Project	IEEE 802.16 Broadband Wireless Access Working Group < http://ieee802.org/16 >	
Title	Corrections to definitions of Uplink MIMO in OFDMA PHY	
Date Submitted	2004-11-01	
Source(s)	Ran Yaniv, Tal Kaitz, Naftali Chayat, Vladimir Yanover Alvarion Ltd.	ran.yaniv@alvarion.com tal.kaitz@alvarion.com
Re:	Call for comments, maintenance task group	
Abstract		
Purpose		
Notice	This document has been prepared to assist IEEE 802.16. It is offered as a basis for discussion and is not binding on the contributing individual(s) or organization(s). The material in this document is subject to change in form and content after further study. The contributor(s) reserve(s) the right to add, amend or withdraw material contained herein.	
Release	The contributor grants a free, irrevocable license to the IEEE to incorporate material contained in this contribution, and any modifications thereof, in the creation of an IEEE Standards publication; to copyright in the IEEE's name any IEEE Standards publication even though it may include portions of this contribution; and at the IEEE's sole discretion to permit others to reproduce in whole or in part the resulting IEEE Standards publication. The contributor

Figure 249—UL STC tile

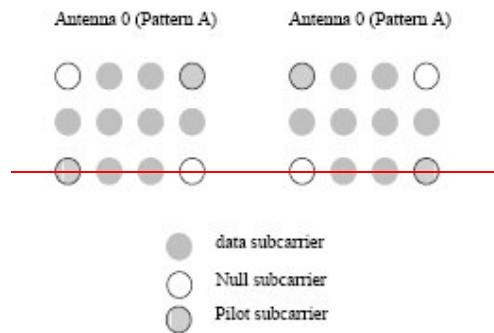
1. The data-subcarrier mapping scheme for UL STTD is not defined (8.4.8.1.5). Note that encoding subcarrier pairs across multiple tiles is not possible due to the existence of the subchannel rotation scheme.

- 1. Correct section 8.4.8.1.5: provide missing definition of STTD mode, define data subcarrier mapping in STTD mode.

A user supporting transmission using STC configuration in the uplink, shall use a modified uplink tile. 2-transmit diversity ('STTD mode') data or 2-transmit spatial multiplexing ('SM mode') data can be mapped onto each subcarrier. The mandatory tile shall be modified to accommodate those configurations. [Figure 249 depicts the UL tile for STC transmission.](#)

Figure 249 – Mapping of data subcarriers in STTD mode.

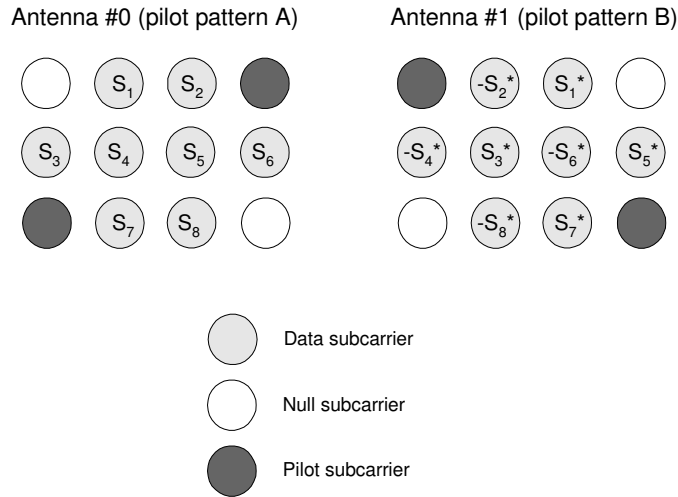
[In STTD mode, the tiles shall be allocated to subchannels and the data subcarriers enumerated as defined in 8.4.6.2. The pilots in each tile shall be split between the two antennas and the data subcarriers shall be encoded in pairs after constellation mapping, as depicted in figure 249. The data subcarriers transmitted from Antenna #0 follow the original mapping defined in 8.4.6.2.](#)

Two single transmit antenna SS's can perform collaborative spatial multiplexing onto the same subcarrier. In this case, ~~the~~ one SS ~~shall should~~ use the uplink tile with pilot-pattern A, and the other SS ~~shall should~~ use the uplink tile with pilot-pattern B. The pilot patterns are depicted in figure 249.
